# Access Compliance Report

## Public Rights-of-Way

### (Curb Ramps)

Intersection ID: 29504	Main Street: ANTHEM_CT	Cross Street: ROSS_MOORE_AV	Location:	N
ADA ID: E898E4C774DA	Ramp Type: BlendTrans1	Initial Pass/Fail: Fail	Overall Compliance: No	Severity Score: 12.5
Codes/Mitigation Info/Possible Solution		Field Measurements/Component Compliance

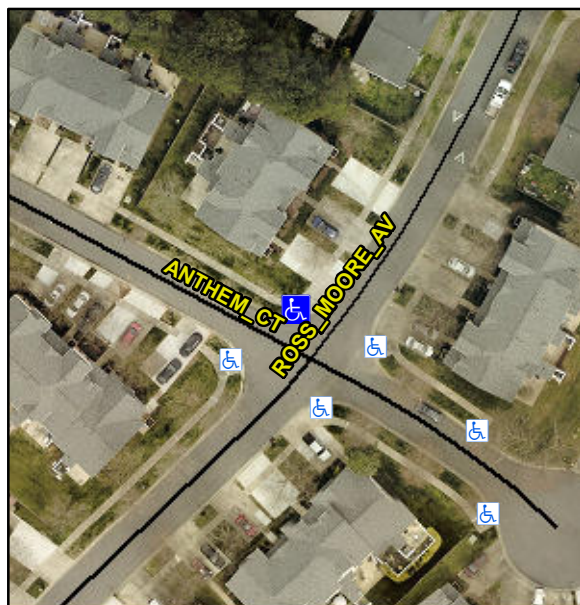
**Not Found, R304.5.3**

Compliance	Description	Data	Compliance	Description	Data
N/A	Ramp Length (in)	74.5	Yes	BlendTrans Slope (%)	3.8
Yes	Ramp Width (in)	61.0	No	BlendTrans XSlope (%)	6.7
N/A	Flare Type LT	N/A	N/A	Flare Type RT	N/A
N/A	Flare Slope LT (%)	N/A	N/A	Flare Slope RT (%)	N/A
N/A	Flare Traversable LT?	N/A	N/A	Flare Traversable RT?	N/A
N/A	Landing Length (in)	N/A	N/A	DWS Provided?	N/A
N/A	Landing Width (in)	N/A	N/A	DWS Contrast?	N/A
N/A	Landing Slope (%)	N/A	N/A	DWS Length (in)	N/A
N/A	Landing X Slope (%)	N/A	N/A	DWS Full Width?	N/A
N/A	Landing Curb? (Y/N)	N/A	N/A	DWS Offset (in)	N/A
N/A	Shared Landing?	N/A			
N/A	Gutter Ponding?	N/A	N/A	Gutter Slope (%)	N/A
N/A	Gutter Lip Ht (in)	N/A	N/A	Gutter X Slope (%)	N/A
N/A	Painted X Walk1?	No	N/A	Painted X Walk2?	No
	X Walk 1 Direction	To SW		X Walk 2 Direction	To SE
	X Walk 1 Width (in)	N/A		X Walk 2 Width (in)	N/A
	X Walk 1 Slope (%)	2.2		X Walk 2 Slope (%)	6.6
	X Walk 1 X Slope (%)	5.4		X Walk 2 X Slope (%)	1.8

N/A	Ramp inside XWalk1?	N/A	N/A	Ramp inside XWalk2?	N/A
	Road Slope (%)	4.8		Clear Space?	N/A
	Road X Slope (%)	3.1	N/A	Clear Space to XWalk (in)	N/A
N/A	Any Obstructions?	N/A	N/A	Storm Grate/Utility Hazard?	N/A
	Obstruction Type			Storm Grate/Utility Type	
		N/A			N/A
			Yes	Surface Condition? (G/P)	Good
			No	Curb Slope (%)	18.1

**Remove & Replace Curb Ramp With Two New Directional Ramps or Equivalent.**
